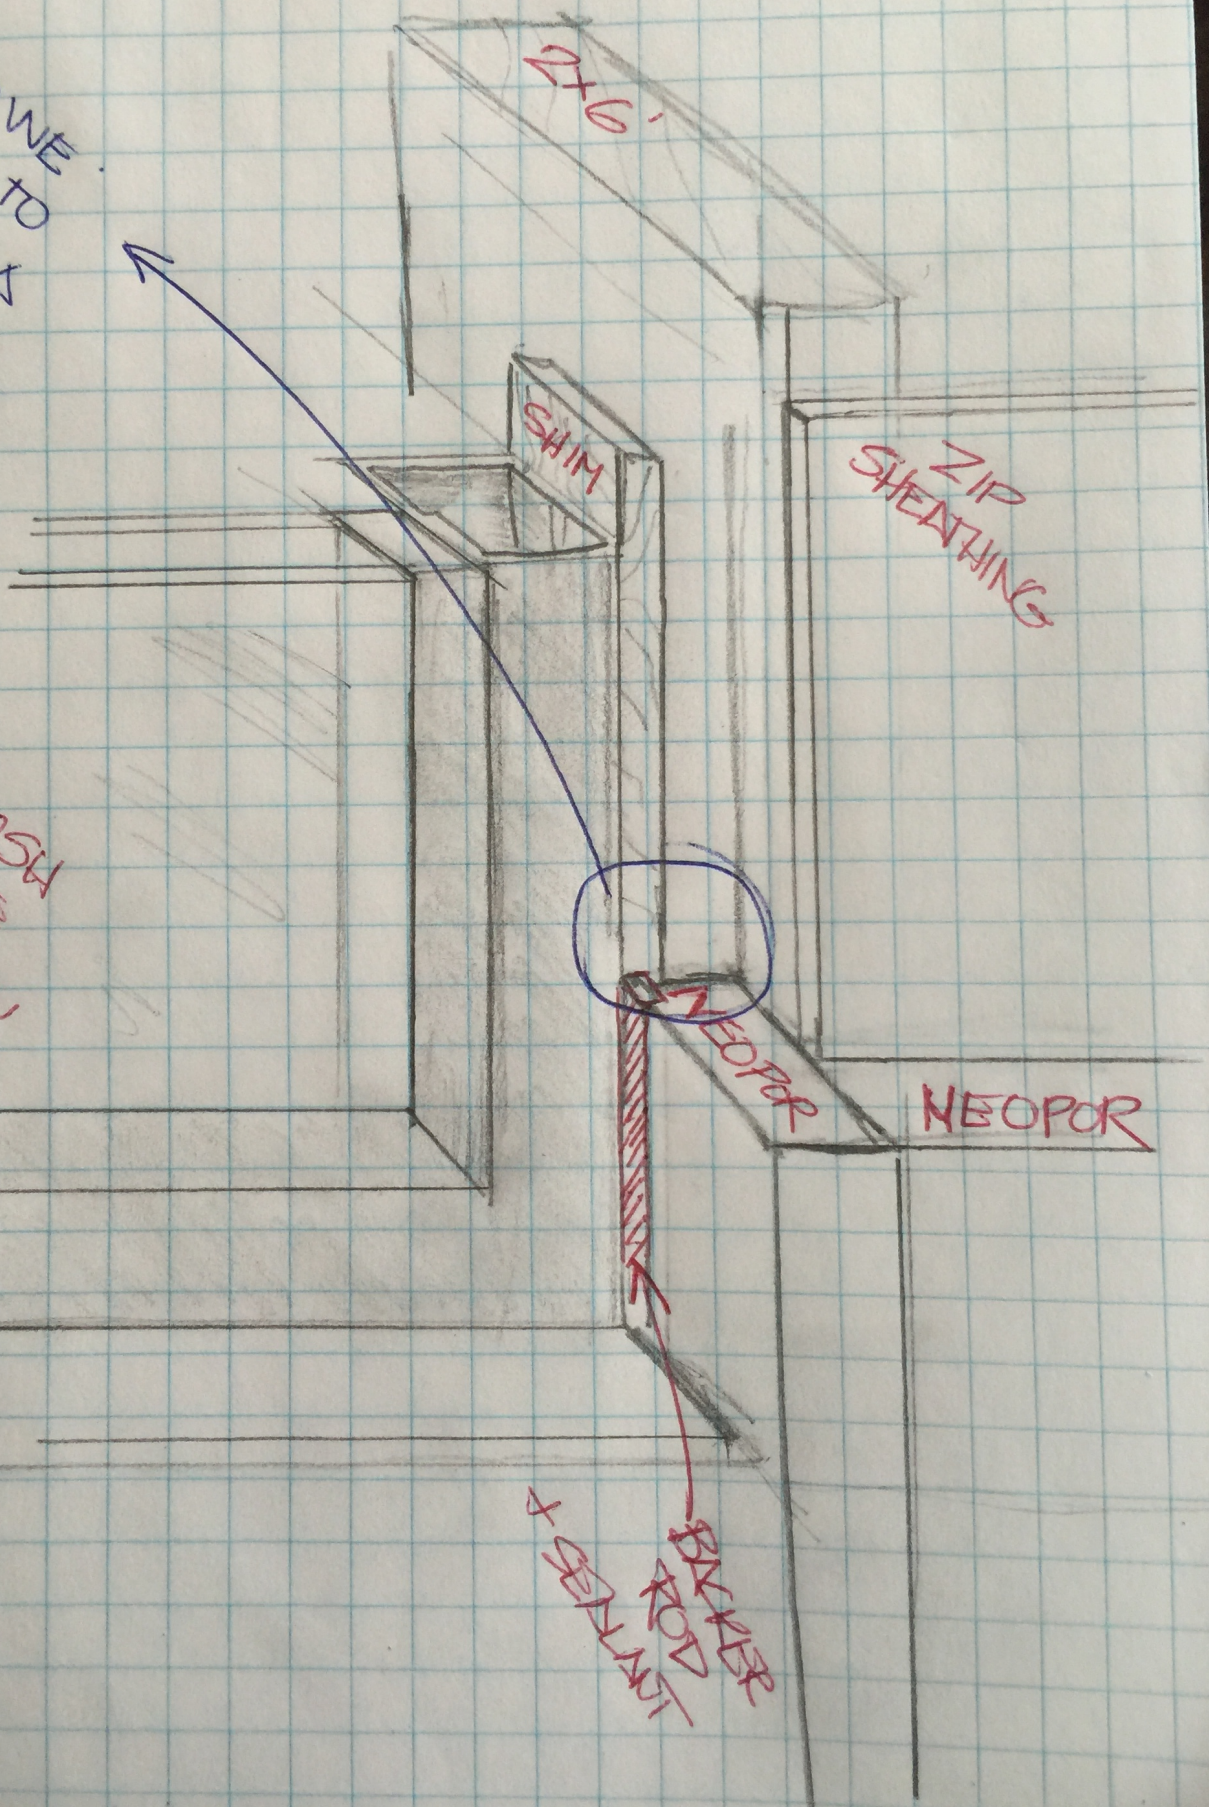
DO WE
NEED TO
CREATE A
FRAME OR
WIDER SHIM
HERE?
